# UNITED STATES PATENT AND TRADEMARK OFFICE

APPLICATION NO.	FILING DATE	FIRST NAMED INVENTOR	ATTORNEY DOCKET NO.	CONFIRMATION NO.
10/707,337	12/05/2003	Staffan Wendeberg	00173.0049.PCUS00	1336
28694	7590	08/12/2004	EXAMINER	
TRACY W. DRUCE, ESQ. 1496 EVANS FARM DR MCLEAN, VA 22101			RODRIGUEZ, SAUL	
			ART UNIT	PAPER NUMBER
			3681

## **DETAILED ACTION**

This is a first office action on the merits of patent application S. N. 10/707,337.

**Fig. 22**

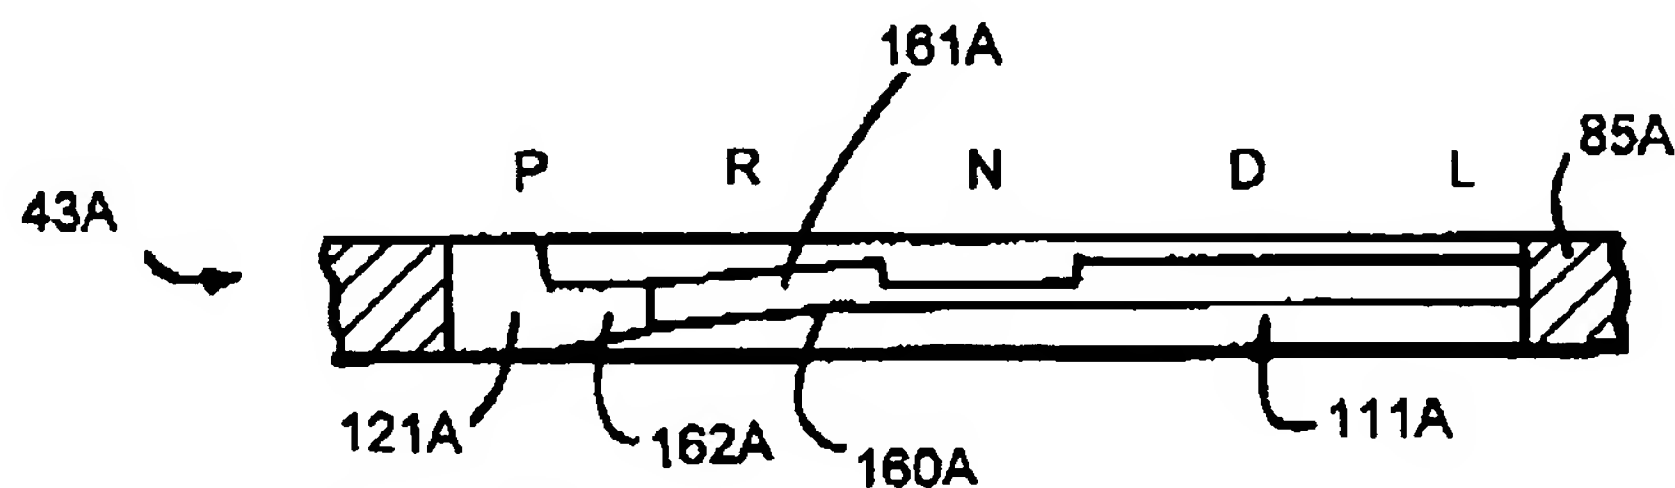
Claims 1 and 5 are rejected under 35 U.S.C. 102(b) as being anticipated by Beattie et al. ('196).

Beattie et al. discloses a gearshift unit comprising a gearshift housing (31), a lever (34), a main pivot axis (Y), an active position range (111A) and a neutral lock (133A), and a pivot pin (113).
